District of Columbia
Office of Planning

MEMORANDUM

SUBJECT: **Public Hearing Report** for ZC #09-08B, Dance Place Second Stage Planned Unit Development

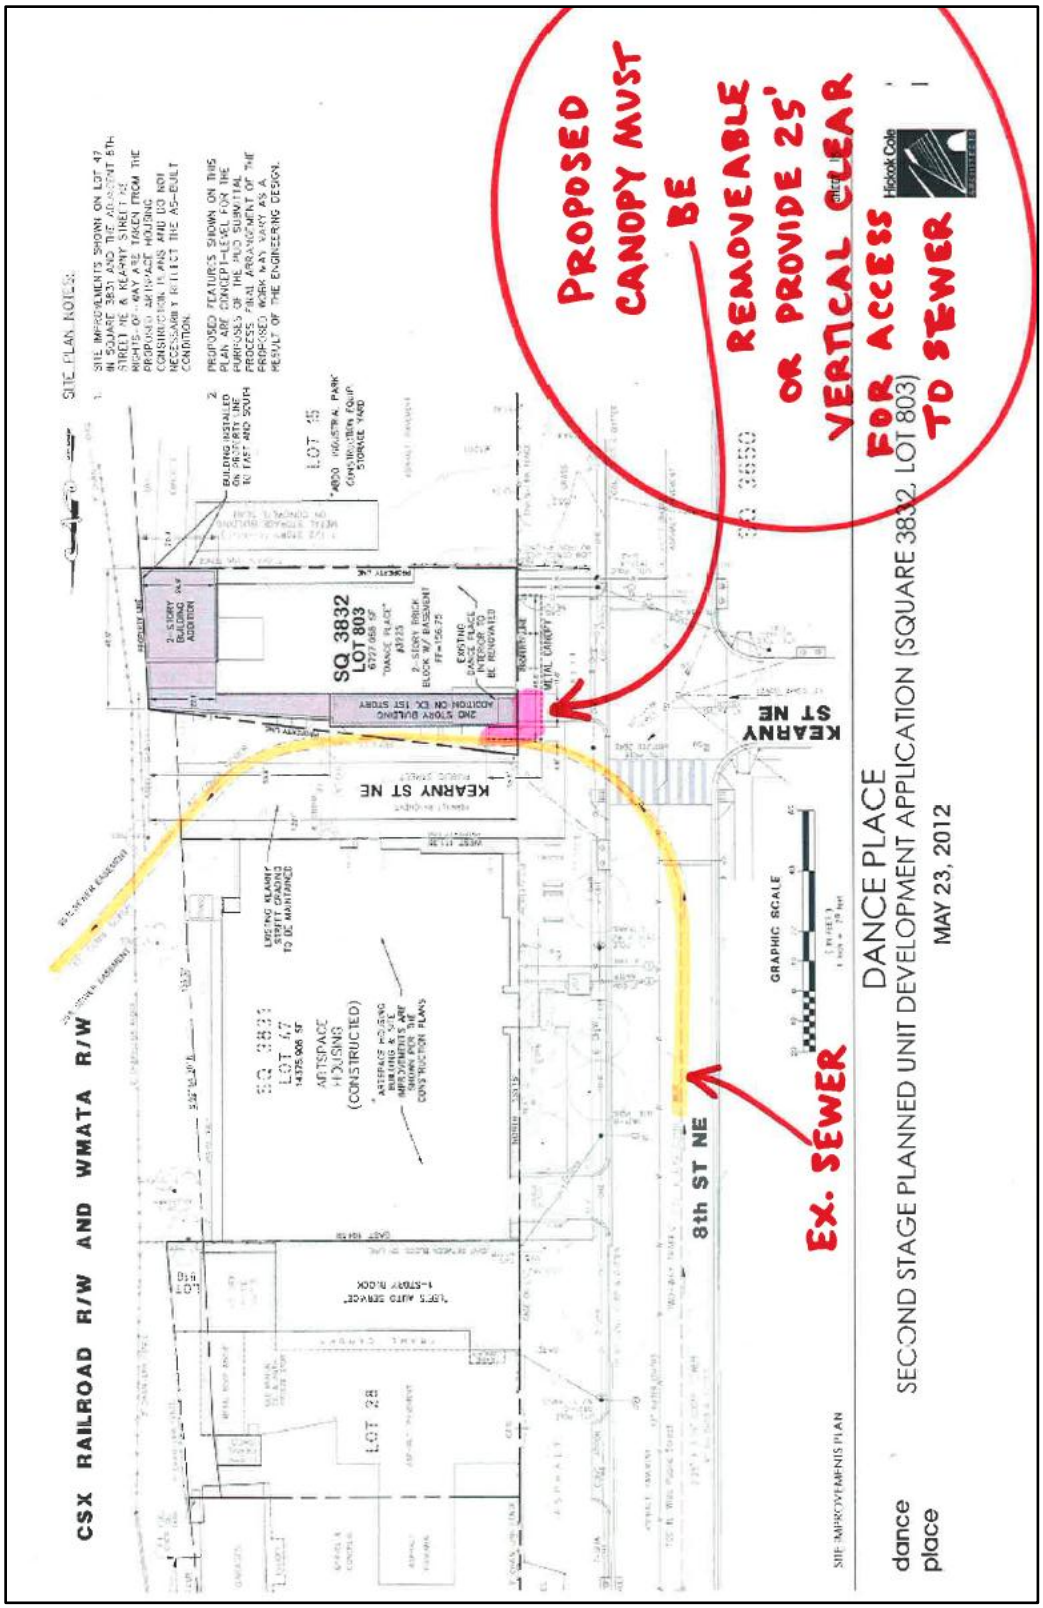
With regard to <u>sewer infrastructure</u> abutting Square 3832, Lot 803, the project site is located in an area with a combined sewer network along 8th Street NE and Kearny Street NE. All proposed sanitary and storm sewer services must be connected to the combined sewer main. There is an existing 2.5' x 3.75' cast in place combined sewer main (constructed in 1896) located approximately four (4) feet from the existing/proposed northern building face. This combined sewer main is available for new sanitary sewer and storm service connections. The structural integrity of this existing, large-diameter sewer should be verified and monitored before, during, and after project construction. Pile driving in the vicinity of the 2.5' x 3.75' combined sewer main may be problematic. NOTE: The proposed canopy on the north side of the proposed building creates an unacceptable conflict for DC Water. The proposed canopy must be removable/retractable or provide a minimum of 25' vertical clearance so as to allow access to the existing 2.5' x 3.75' combined sewer main. See attached exhibit.
